## North Coast Regional Water Quality Control Board

**Subject: Notice of Violation, Directive to Obtain Regulatory Coverage for Cannabis Cultivation, and Transmittal of Inspection Report for September 4, 2019, Inspection of Humboldt County Assessor's Parcel Nos. 315-173-004 and 315-174-003**

### **Inspection Report for September 04, 2019, Warrant Inspection Humboldt County Assessor's Parcel Numbers 315-173-004 and 315-174-003**

Figure 1 inspection map with inspection points

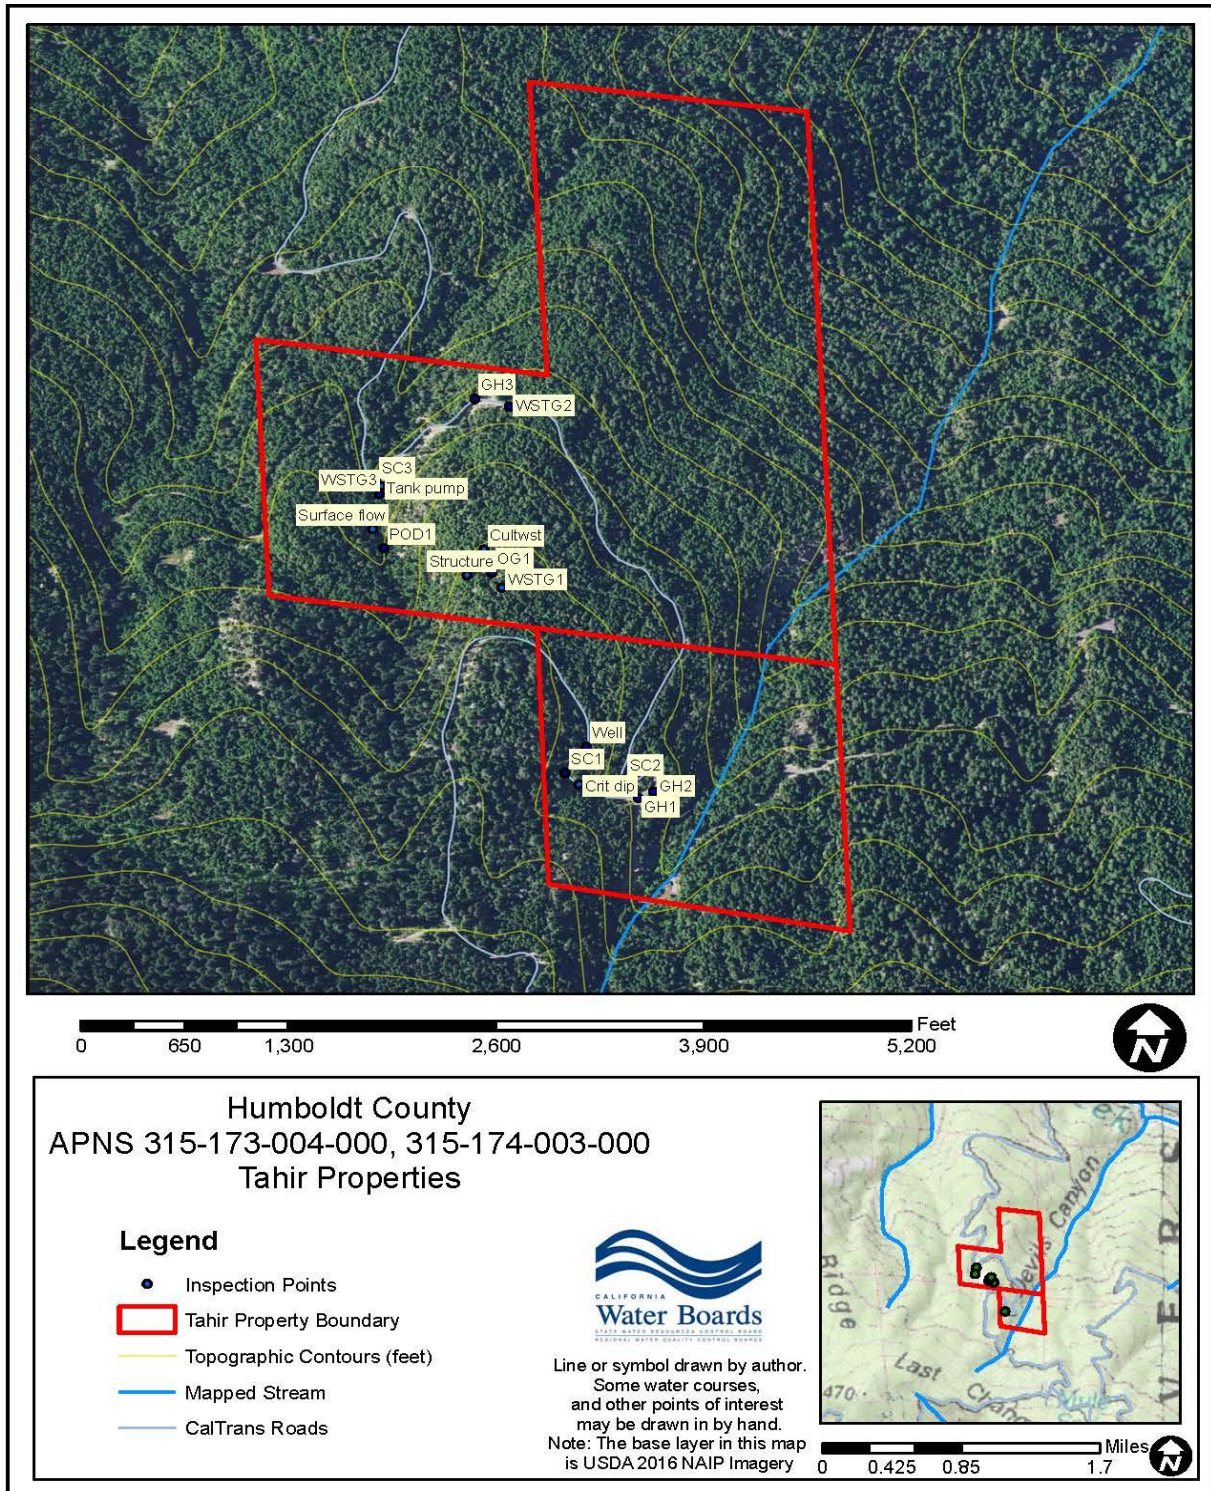
On September 4, 2019, I inspected the subject property. Figure 1, above, shows the inspection points discussed below, including GH1, GH2, GH3, OG1, SC1, SC2, SC3, Well, Crit Dip, WSTG1, WSTG2, WST3, Cultwst, POD1, Surface flow and Tank pump. In addition to those features marked on the inspection map, we observed, and photo-documented green houses, human waste, stream crossings, water storages, cultivation waste and other issues of water quality concern.

In addition to the cannabis cultivation areas, I observed stream crossings SC1, SC2, SC3. Crossing SC1 (photo 1) is about 1600 feet from the southern property line. The road is built through a Class III watercourse at this location, with an undersized, plugged, and rusted corrugated metal pipe culvert. I observed evidence of sediment delivery into the watercourse at this crossing. SC2 (Photo 2) is a Class III stream crossing on the southern access road, approximately 400 feet to the east of SC1, with no constructed feature to provide stable conveyance for stream flows. I observed evidence of erosion and sediment discharge into the watercourse. SC3 is approximately 2,500 feet Northwest of SC2 (photo 15), blown out stream crossing, delivered about 1,500 cubic yards of sediment to the class II watercourse.

1. Site maintenance, erosion control and drainage features: I observed a poorly designed access road with a potential of delivering sediment to the waters of the state.

2. Stream crossing maintenance and improvement: I observed 3 stream crossings (SC1, SC2, and SC3) on the access road to the property; as discussed above, all were constructed either improperly or without any structure or design to protect water quality. All three crossings are causing or resulting in active discharge of sediment to class II and III watercourses. (Photos 1,2 and 15)

1. Retain a licensed professional to inventory, assess, and develop a workplan and schedule to implement measures to ensure that all developed features, roads, watercourse crossings, and cultivation areas throughout the Property are corrected, restored, and/or maintained in conditions that prevent or minimize erosion, sediment transport/delivery, and adverse impacts to water quality and beneficial uses. Include measures to ensure that unstable features caused or affected by onsite development and operations are removed or otherwise protected so as to minimize the potential for these features to cause adverse impacts to water quality and beneficial uses. Dispose of all development and restoration-related earthen spoils in a manner to prevent/minimize transport and delivery to receiving waters.

2. Work with CDFW and the State Water Resources Control Board's Division of Water Rights (DIV) to determine and secure any applicable permits or licensing required for surface water diversion, storage, and use on the site. If the existing surface water diversions do not meet applicable CDFW or DIV requirements, remove diversion infrastructure from surface waters and ensure that restoration plans developed pursuant to Recommendation 1, above, include provisions for restoring any instream or riparian disturbance associated with this features or removal thereof.

3. Prior to conducting any instream work associated with recommendation 1, above, submit to the Regional Water Board an application for Clean Water Act section 401 water quality certification, and secure approval from the Regional Water Board.
